Meeting: BOWDA Teepee Town ARP Meeting

Date: January 26, 2017

ATTACHMENT A

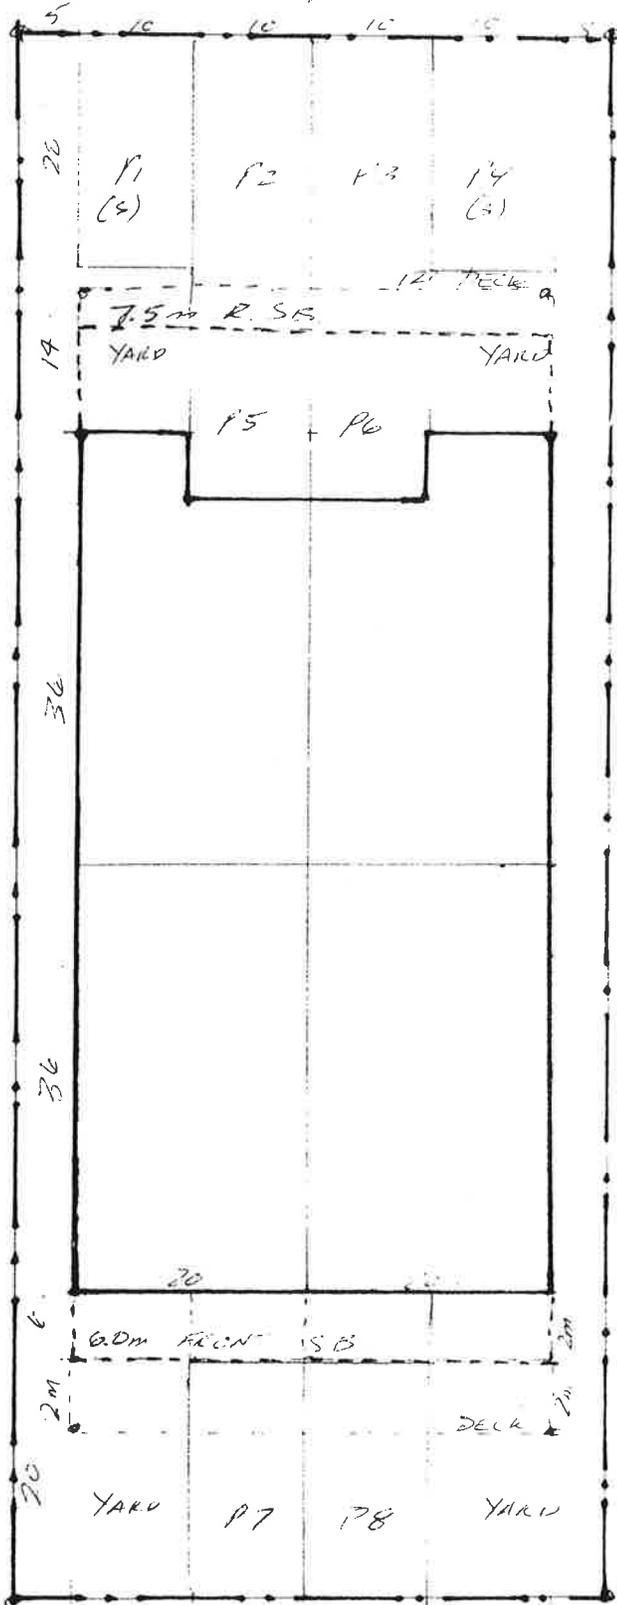
- Setbacks (varied and contextual, building towards the street) & Parking
 - Tanya proposed to the group a new front yard setback of 4m.
 - Tanya provided a site plan (Attachment A) demonstrating the concept.
 - Tanya indicated that this setback was ideal, as it centres the building relative to the front (in the ROW) and rear parking to allow each unit equal amenity space.

- Administration did note that the design requires permission to utilize the road right of way, in the form of tandem parking, to ensure parking requirements are met.

- Administration raised concerns regarding the proposed decks covering the proposed amenity spaces, rendering them less usable.
 - Administration raised concerns regarding the elimination of visitor parking through permitting parking in the ROW with the additional stalls required to satisfy parking requirements for suites.

- More discussion regarding the impacts of parking in the ROW occurred. Questions arose regarding whether cars parked perpendicularly allow for adequate space for the road, a sidewalk and parking on each side of the road. Administration indicated they would discuss parking arrangement with Engineering.

7.5m REAR S.B. & 6.0m FRONT SETBACK.
 - NOT IDEAL - FORCES BUILDING TO BE
 BACK ON LOT & LIMITS REAR PARKING
 - BUILDING NEEDS TO MOVE FORWARD
 AIM TO GET EQUAL SIZED YARDS,
 4 UNITS & ALLOW FOR 12 PARKING SPOTS
